Subject: MHI's Response to US-APWR DCD RAI No. 545-4290 Rev. 1

Response to Request for Additional Information
No. 545-4290 Revision 2

RAI NO.: NO. 545-4290 REVISION 2
SRP SECTION: 04.03 – Nuclear Design
APPLICATION SECTION: 4.3
DATE OF RAI ISSUE: 3/3/2010

Figure 04.03-56.1 Structure of Neutron Reflector and Core Barrel

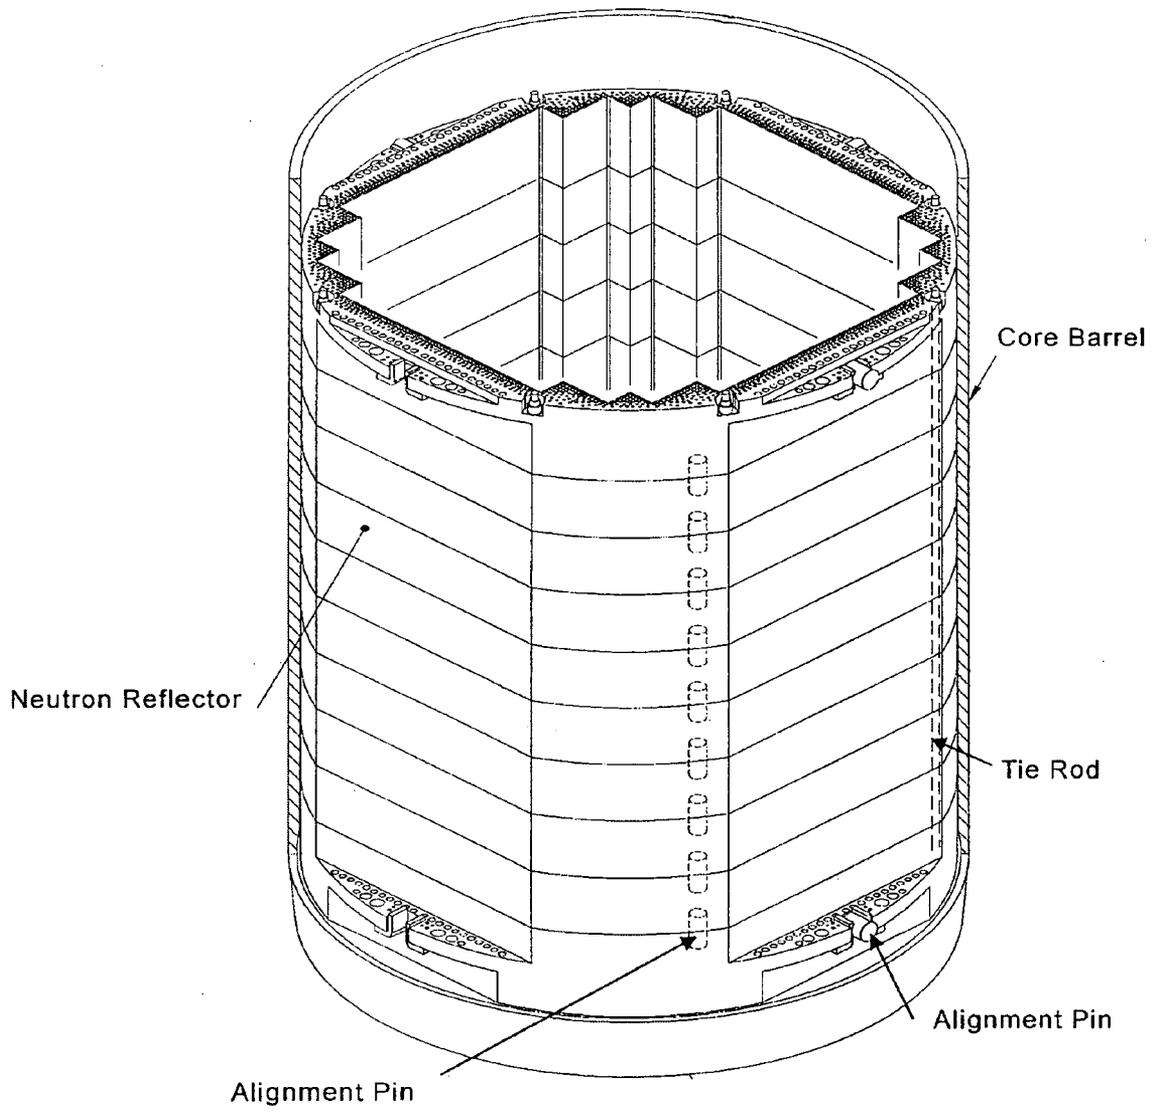
The former-plates between the baffle and core-barrel of Figure-A-2 of MUAP-09018 can have a significant effect on the vessel fluence prediction. Provide an axial and radial description of the former plates (if they are present in the US-APWR) and any other structures/supports located in the region between the core and the vessel. Have the former-plates and all supports/structures between the core and vessel been included in the calculational models? If not, update the models to include these effects and provide the resulting changes in the calculated vessel fluence. The uncertainty and bias introduced by any approximations in representing these structures should also be determined and incorporated in the fluence analysis.

The design of the US-APWR core internals incorporates the neutron reflector but not the former-plates. As shown in Figure 04.03-56.1, the design includes tie rod and alignment pins that are modeled as the same stainless steel as the neutron reflector.
